<b>Status</b>	2 - Disposition Needed	<b>Trend</b>	07-Out Of Tolerance
<b>Department</b>	NCSX	<b>Division</b>	125
<b>Source/Org</b>	Fabrication, Operations & Maintenance		
<b>Item Dwg/Part#</b>	SE310-035	<b>Procurement #</b>	
<b>RAP#</b>	3268	<b>Job Doc #</b>	D-NCSX-FPA-001
<b>RAP Title</b>	Field Period Assembly Station One

**NCR 3733 – Attachment 1 – 10/26/07**

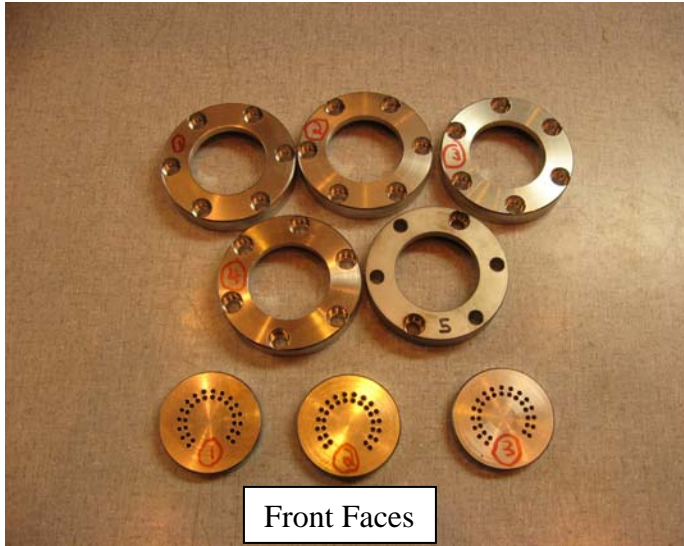
VVSA-1, 2, 3: Five (5) of the NCSX vacuum vessel diagnostic loop cryostat feedthrough Conflat flanges and three (3) associated feedthrough discs exhibit a magnetic permeability greater than is allowed by NCSX-ASPEC-GRD-05 paragraph 3.3.1.1 (<1.05 Mu). See attachment 1 for details and pictures. These parts have been annealed in the vacuum brazing furnace and the readings reported are post annealing.

Conflat Flanges – 2.73” OD x 0.50” thick

Sample 1      Front & Back Faces = >1.1, <1.2 Mu  
 Sample 2      Front & Back Faces = >1.1, <1.2 Mu  
 Sample 3      Front & Back Faces = >1.1, <1.2 Mu

Sample 4      Front & Back Faces = >1.1, <1.2 Mu  
 Sample 5      Front & Back Faces = >1.06, <1.08 Mu  
                     Iso. spots of >1.09, <1.1 Mu

Outer Edge = >1.1, <1.2 Mu  
 Outer Edge = >1.09, <1.1 Mu  
 Outer Edge = >1.08, <1.09 Mu  
                     Iso. spots of >1.09, <1.1 Mu  
 Outer Edge = Iso. spots of >1.06, <1.08 Mu  
 Outer Edge = >1.06, <1.08 Mu

Feedthrough Discs – 1.90” OD x 0.25” thick

Sample 1      Front Face & Outer Edge = <1.05 Mu  
 Sample 2      Front Face & Outer Edge = <1.05 Mu  
 Sample 3      Front Face & Outer Edge = <1.05 Mu

Back Face = >1.06, <1.08 Mu  
 Back Face = >1.06, <1.08 Mu  
 Back Face = >1.06, <1.08 Mu  
                     Iso. Spots of >1.08, <1.09 Mu
